Technical Service Information

FORD 4R100 PRELIMINARY INFORMATION

CHANGE: Beginning at the start of production for 1999 models, Ford Motor Company introduced a new transmission in some F250, F350, F450 and F550 Super Duty Trucks, equipped with the 5.4L, 6.8L and 7.3L engines. Basically the new 4R100 is a revised version of the previous E4OD transmission with a Power-Take-Off (PTO) window on the side of the case (See Figure 1). The revisions that have occurred however, have created many major engineering changes that have affected many internal and external parts that will affect service.

Figure 8

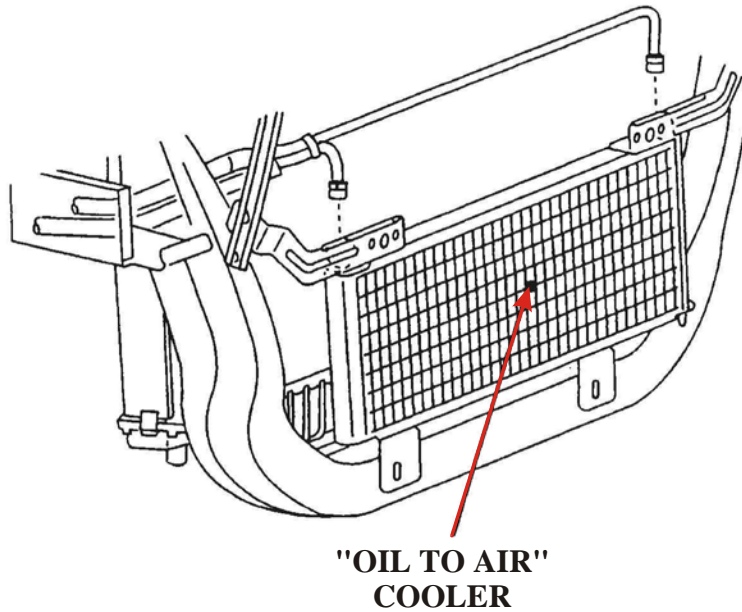
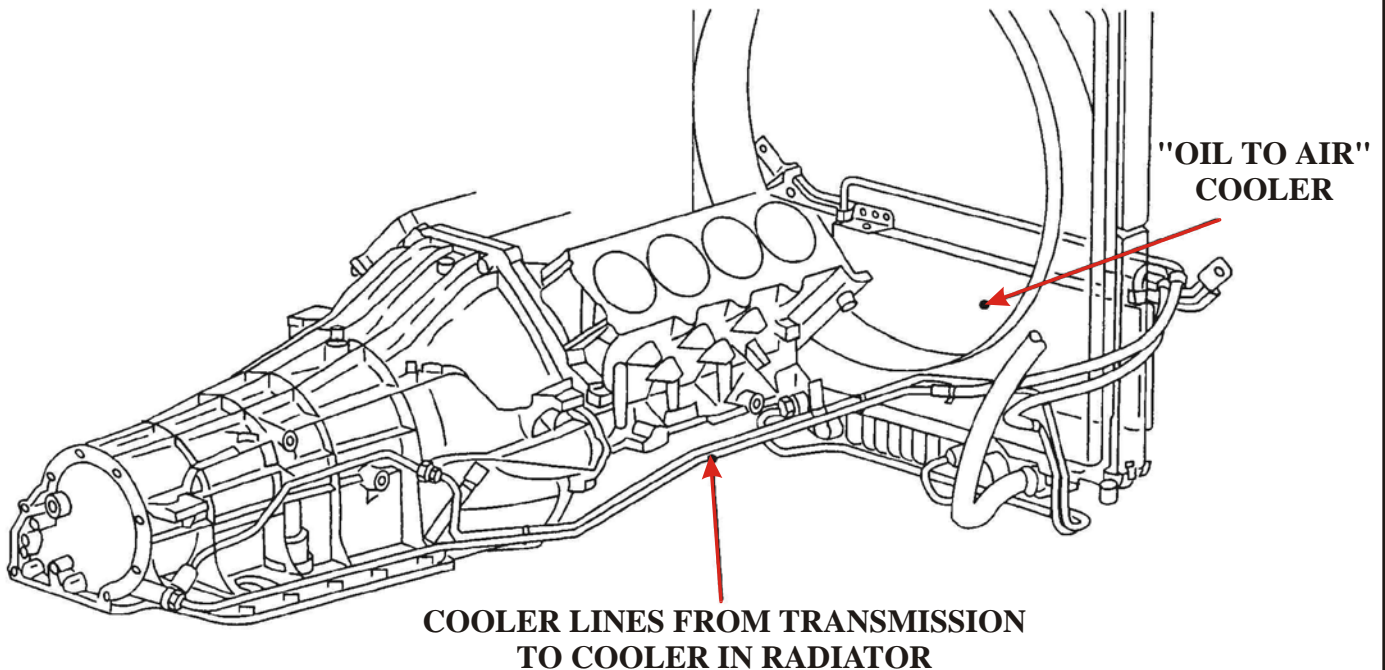
- (8) **TRANSMISSION COOLERS** - Most F-Series vehicles over 8500 GVW equipped with the 4R100 transmission have an external "Oil-To-Air" cooler **only**. Due to the internal design of the "Oil-To-Air" cooler, it cannot be adequately flushed to remove contaminants, and requires replacement during transmission rebuild. The only exception is that F-Series vehicles over 8500 GVW equipped with the 5.4L engine also uses a radiator "In-Tank" cooler in addition to the "Oil-To-Air" cooler. Refer to Figure 8 for transmission cooler information.

Most F-Series vehicles over 8500 GVW equipped with the 4R100 transmission have an external "Oil-To-Air" cooler only. Due to the internal design the "Oil-To-Air" cooler cannot be adequately flushed to remove contaminants, and requires replacement during transmission rebuild.

The only exception is that F-Series vehicles over 8500 GVW equipped with the 5.4L engine also uses a radiator "In-Tank" cooler in addition to the "Oil-To-Air" cooler.

Figure 9

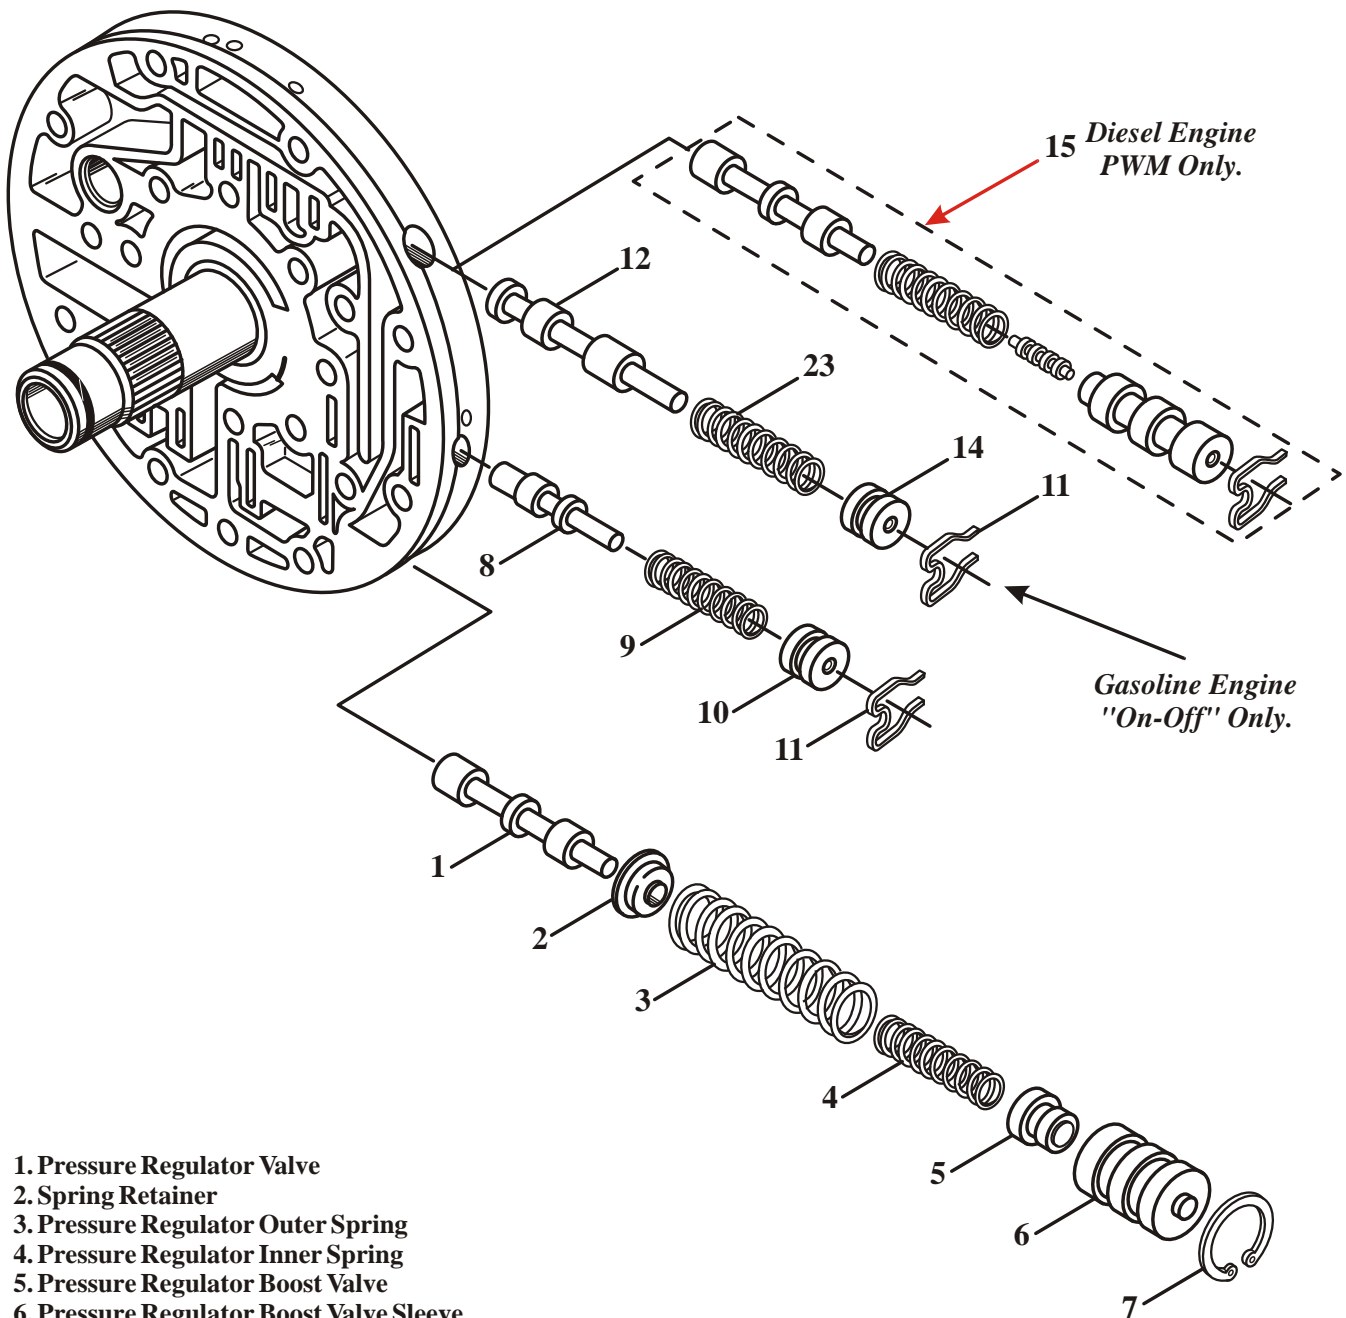
- (9) **FRONT PUMP COVER** - The pump cover is basically the same as the E4OD, but has a different valve line-up in the Converter Clutch Control Valve bore. The gasoline applications all have an "On-Off" lock-up solenoid and the 7.3L diesel applications all have a Pulse Width Modulated (PWM) lock-up solenoid. This changes the Converter Clutch Control Valve line-ups in the pump cover, as shown in Figure 9.

Figure 10

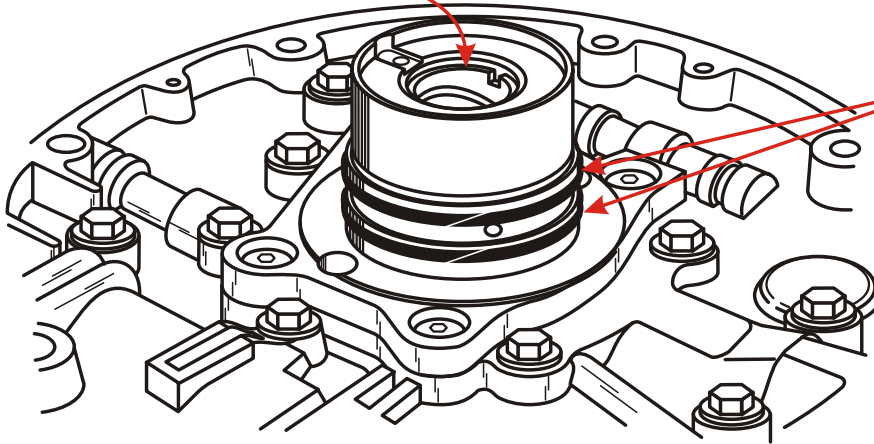
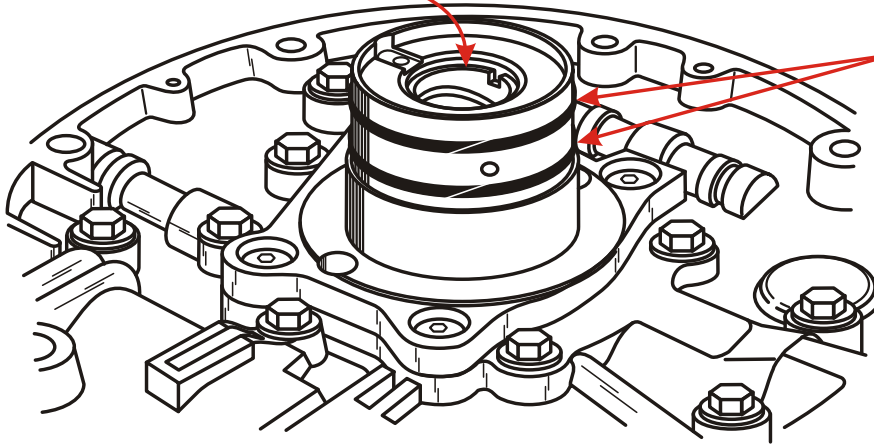
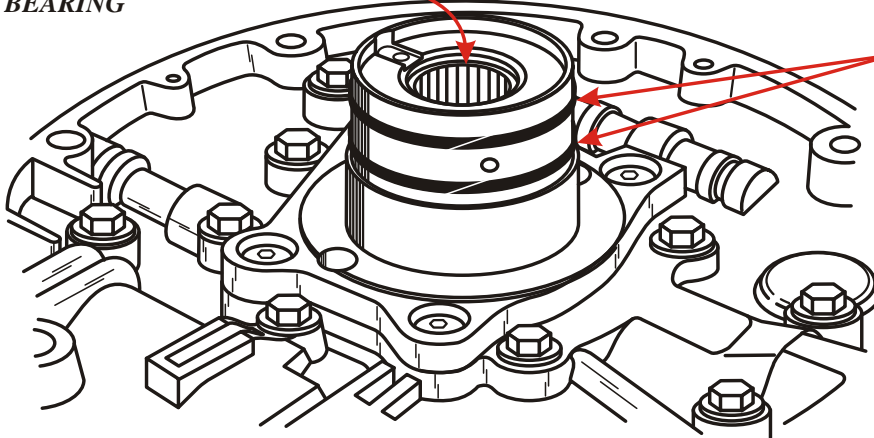
- (10) **FRONT PUMP STATOR SHAFT** - With the addition of the PTO gear on the front of the coast clutch drum, it was necessary to move the coast clutch sealing ring grooves up on the pump stator shaft to accommodate the coast clutch drum moving. There are currently three different Pump Stator Shafts used in production and all three are illustrated in Figure 10. One is the current E4OD shaft which is used with the "Cast Iron" coast clutch drum with 5.4L and 6.8L engines **without** the PTO option. Two is the shaft with the relocated sealing rings and a bushing in the pump tower, which is used with the "Stamped Steel" coast clutch drum with 5.4L and 6.8L engines **without** the PTO option. Third is the shaft with the relocated sealing rings and a caged needle bearing in the pump tower, which is used with the "Stamped Steel" coast clutch drum with 6.8L and 7.3L engines **with** the PTO option. Refer to Figure 10.

**COAST CLUTCH
SEAL RINGS ARE
LOW ON PUMP TOWER
(LIKE E40D)**

**COAST CLUTCH
SEAL RINGS ARE HIGHER
ON THE PUMP TOWER**

**COAST CLUTCH
SEAL RINGS ARE HIGHER
ON THE PUMP TOWER**

Figure 11

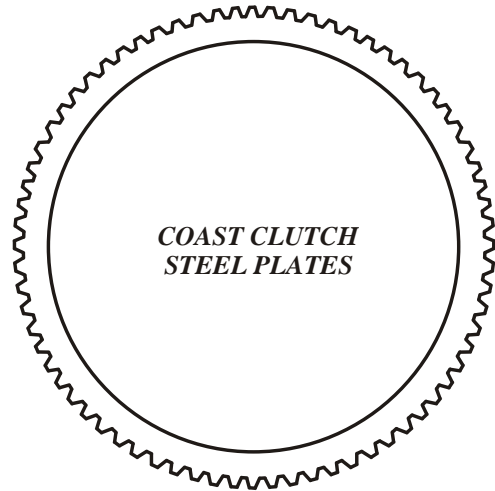
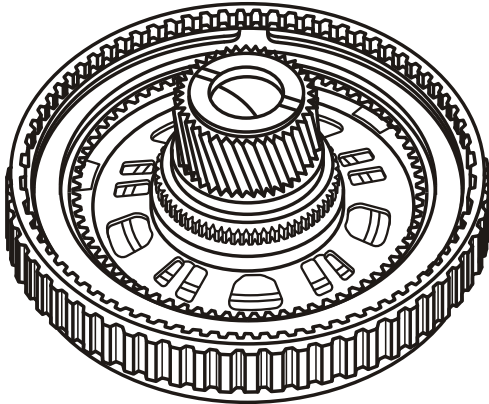
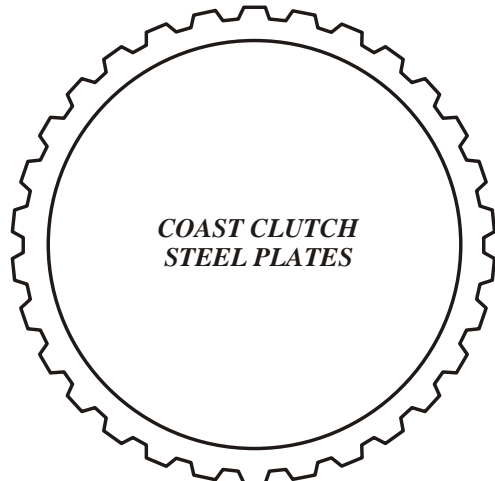
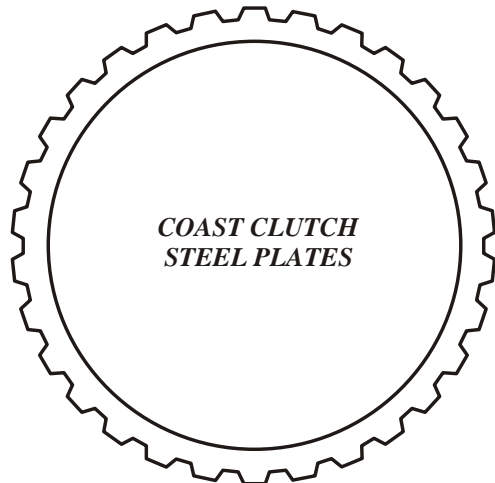
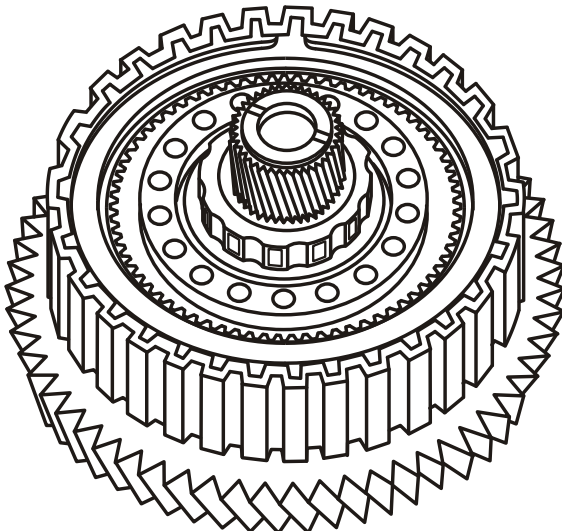
- (11) **COAST CLUTCH DRUM AND STEEL PLATES** - There is now a revised "Stamped Steel" coast clutch drum introduced with the 4R100 transmission. There are currently three different coast clutch drums used in production and all three are illustrated in Figure 11. One is the current E4OD coast clutch drum which is "Cast Iron" and uses the current steel plates. Two is the new design "Stamped Steel" coast clutch drum without the PTO gear pressed on it and uses a new design coast clutch steel plate to accommodate the new drum. Third is the new design "Stamped Steel" coast clutch drum with the PTO gear pressed on it and uses the new design coast clutch steel plates to accommodate the new drum. The new design "Stamped Steel" coast clutch drum now has the overdrive roller clutch inner cam made on the drum and the overdrive sun gear is pressed into the new design drum, which changes the assembly process of the overdrive roller clutch. Refer to Figure 11.

Figure 12

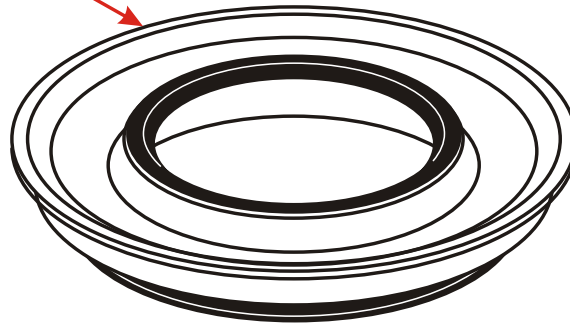
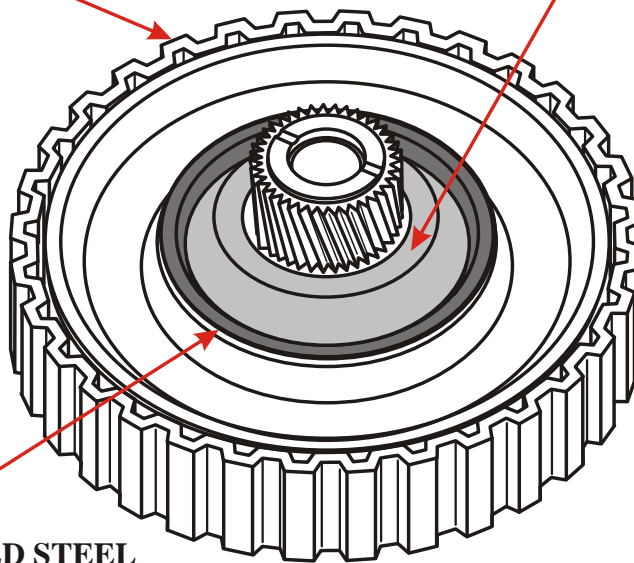
- (12) **COAST CLUTCH PISTON** - The coast clutch piston in the new design coast clutch drum is now a stamped steel, molded rubber seals assembly and is illustrated in Figure 12. The new design piston assembly requires a new seal protector tool, Rotunda No. 307-387, to install the piston and seal assembly into the new design stamped steel coast clutch drum (See Figure 12).

**NEW DESIGN STAMPED STEEL,
MOLDED RUBBER SEAL PISTON
OEM PART NUMBER F81Z-7A262-AA**

**LIP SEAL PROTECTOR
ROTUNDA NO. 307-387**

Figure 13

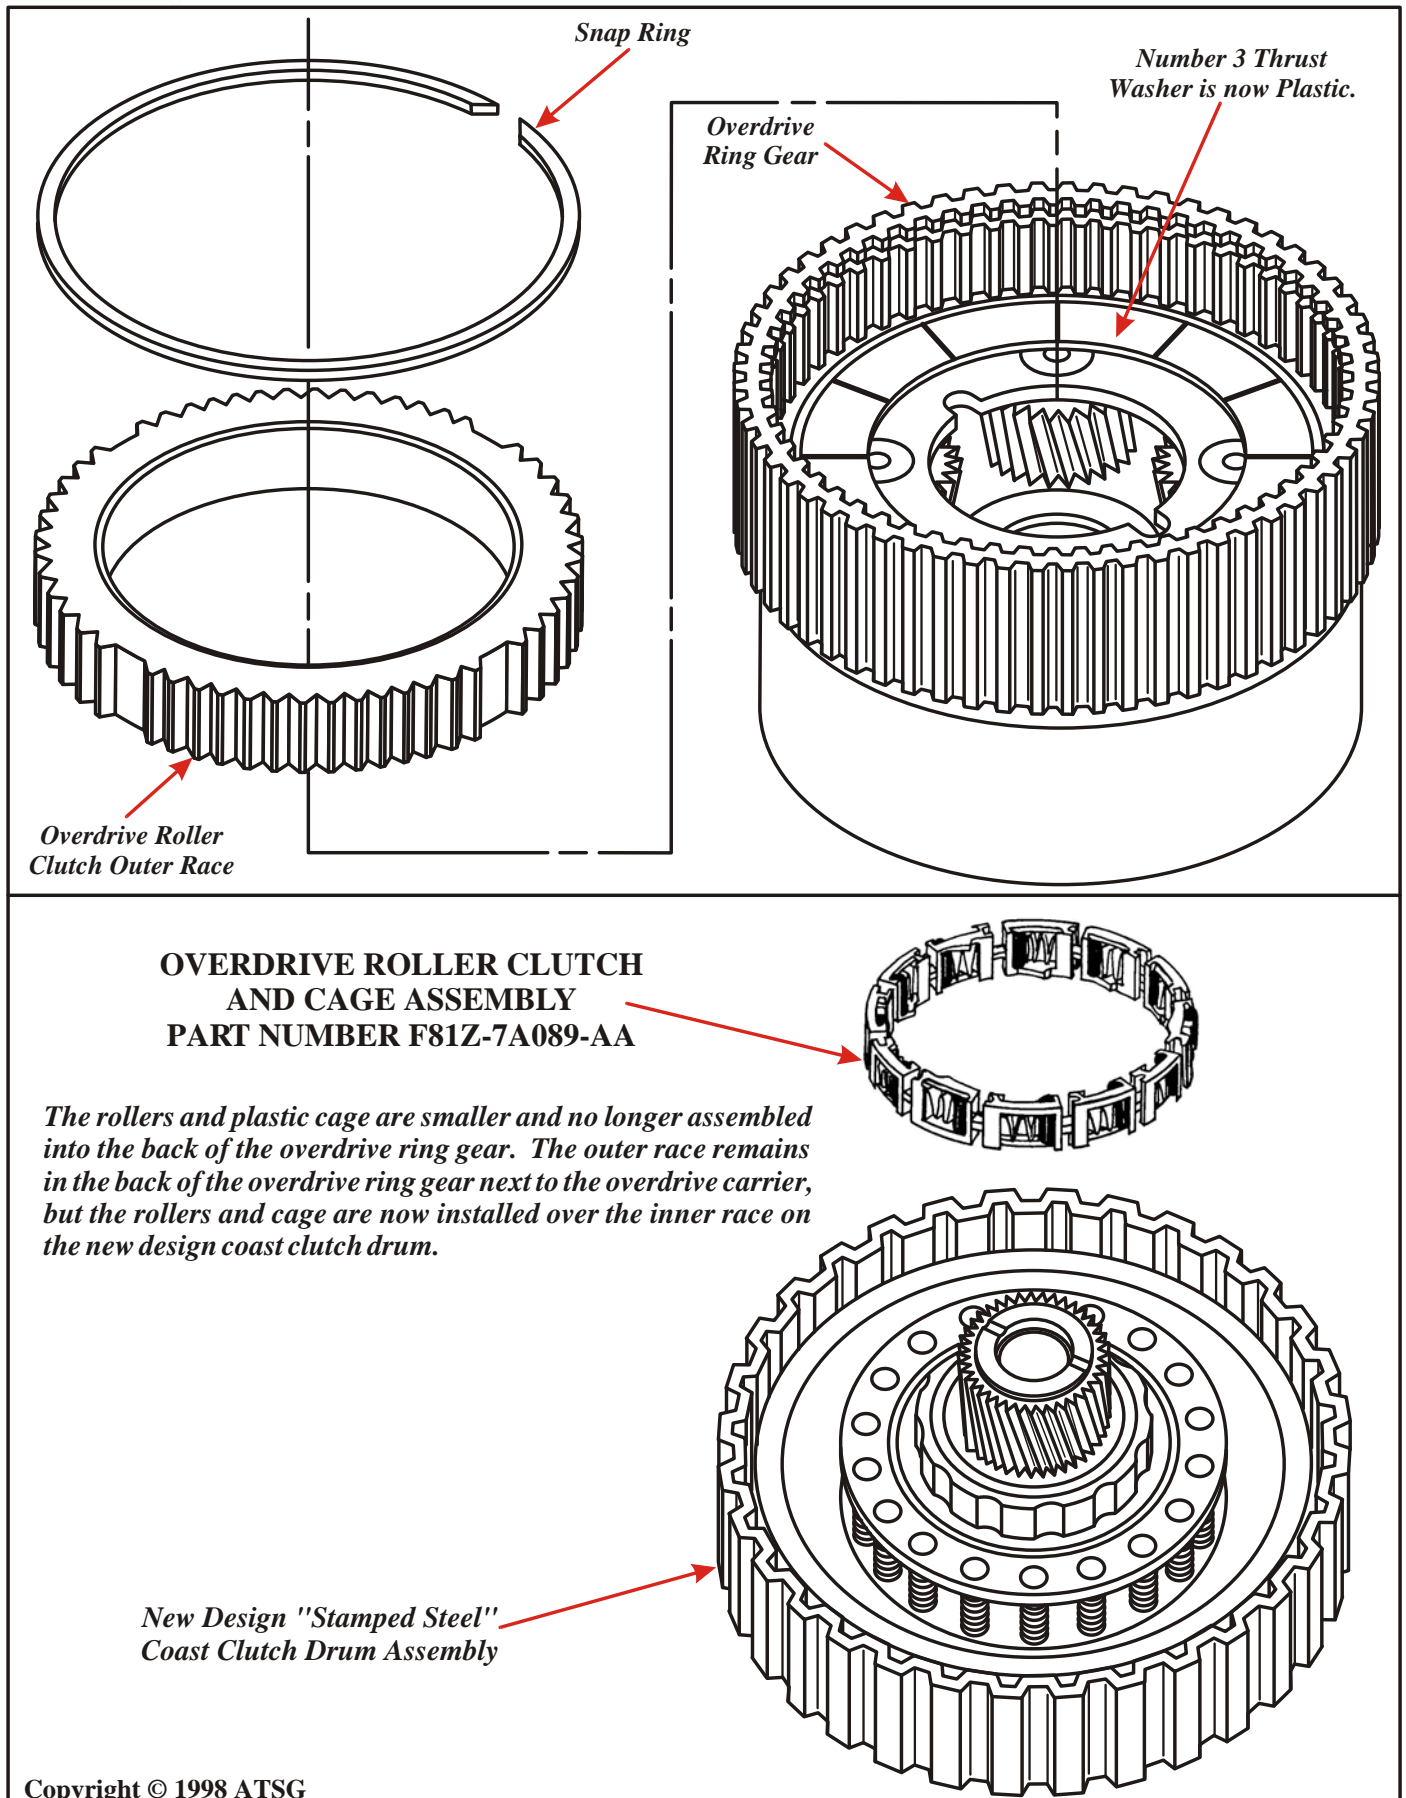
- (13) **OVERDRIVE ROLLER CLUTCH** - The overdrive roller clutch inner cam is now made onto the new design coast clutch drum, instead of being splined like the previous models were, and is illustrated in Figure 13. The new design overdrive roller clutch assembly is now assembled onto the inner cam on the new design drum. The overdrive roller clutch outer race is still located in the overdrive ring gear next to the overdrive carrier and the number 13 thrust washer between the two is now plastic, but the cage and roller assembly are now assembled over the inner race on the new design coast clutch drum. Refer to Figure 13.

Figure 14

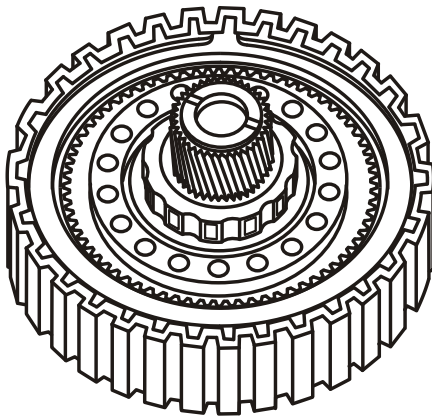
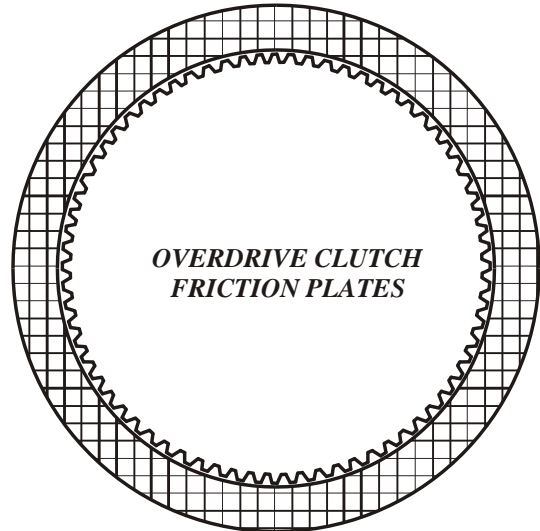
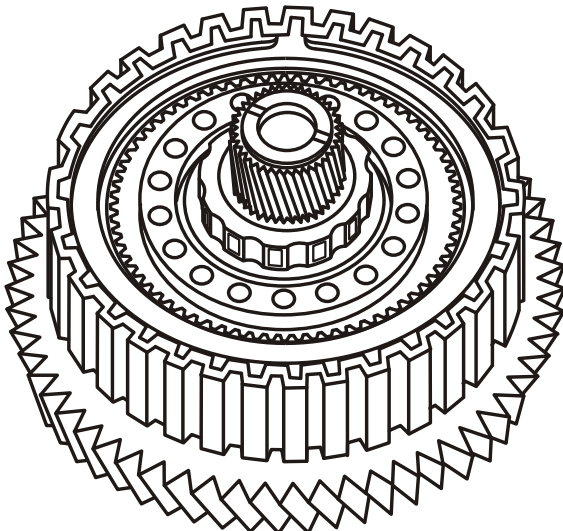
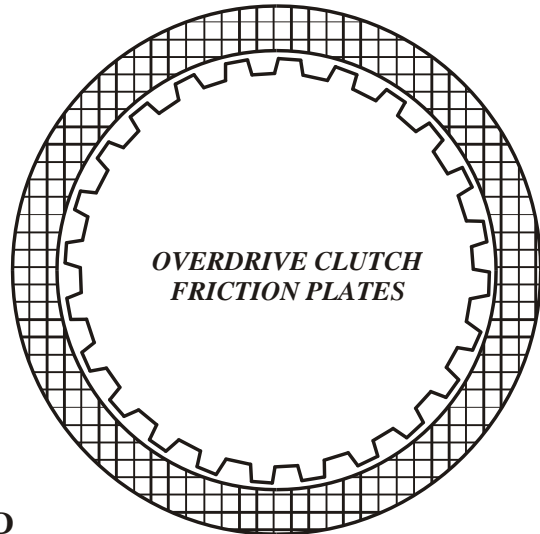
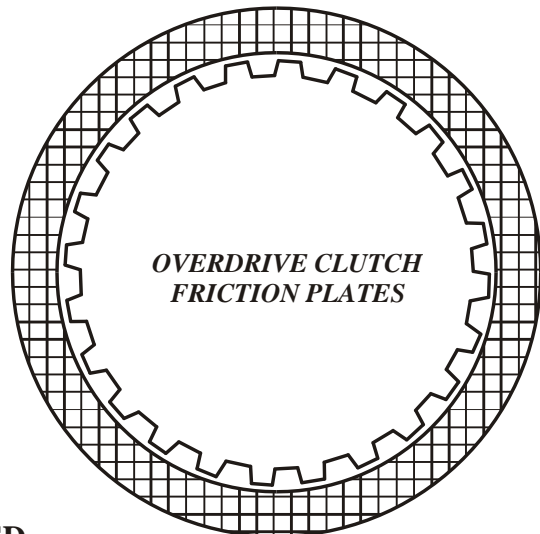
- (14) **OVERDRIVE FRICTION PLATES** - Now have wider teeth to accommodate the new design stamped steel coast clutch drum assembly when it is used, as illustrated in Figure 14.
